# Access Compliance Report

## Public Rights-of-Way

### (Curb Ramps)

Intersection ID: 14147	Main Street: CHERRY_ST	Cross Street: LUTHER_ST	Location: W
ADA ID: 5DF304AC1D53	Ramp Type: Perpendicular Diagonal	Initial Pass/Fail: Fail	Overall Compliance: No
			Severity Score: 18.75

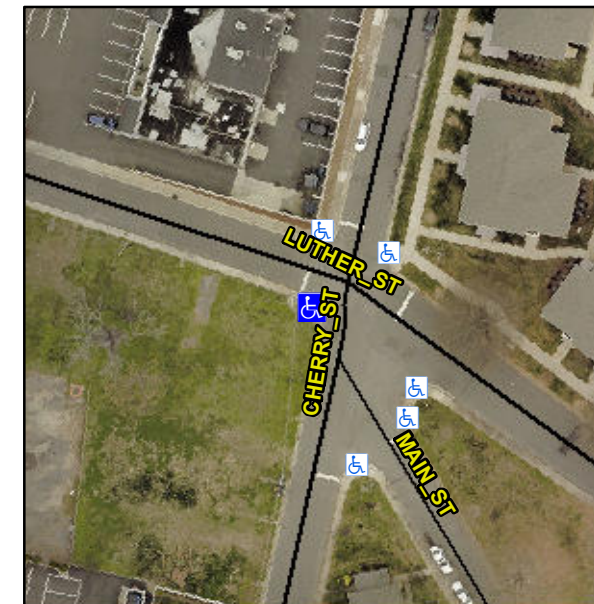
**R304.5.1, R304.5.3**

Compliance	Description	Data	Compliance	Description	Data
N/A	Ramp Length (in)	46.0	Yes	Ramp Slope (%)	5.1
No	Ramp Width (in)	32.0	No	Ramp XSlope (%)	2.5
N/A	Flare Type LT	N/A	N/A	Flare Type RT	N/A
N/A	Flare Slope LT (%)	N/A	N/A	Flare Slope RT (%)	N/A
N/A	Flare Traversable LT?	N/A	N/A	Flare Traversable RT?	N/A
N/A	Landing Length (in)	N/A	N/A	DWS Provided?	N/A
N/A	Landing Width (in)	N/A	N/A	DWS Contrast?	N/A
N/A	Landing Slope (%)	N/A	N/A	DWS Length (in)	N/A
N/A	Landing X Slope (%)	N/A	N/A	DWS Full Width?	N/A
N/A	Landing Curb? (Y/N)	N/A	N/A	DWS Offset (in)	N/A
N/A	Shared Landing?	N/A			
N/A	Gutter Ponding?	N/A	N/A	Gutter Slope (%)	N/A
N/A	Gutter Lip Ht (in)	N/A	N/A	Gutter X Slope (%)	N/A
N/A	Painted X Walk1?	No	N/A	Painted X Walk2?	No
	X Walk 1 Direction	To SE		X Walk 2 Direction	To NE
N/A	X Walk 1 Width (in)	N/A	N/A	X Walk 2 Width (in)	N/A
	X Walk 1 Slope (%)	0.6		X Walk 2 Slope (%)	1.6
	X Walk 1 X Slope (%)	3.2		X Walk 2 X Slope (%)	6.2

**Remove & Replace Curb Ramp With Two New Directional Ramps or Equivalent.**
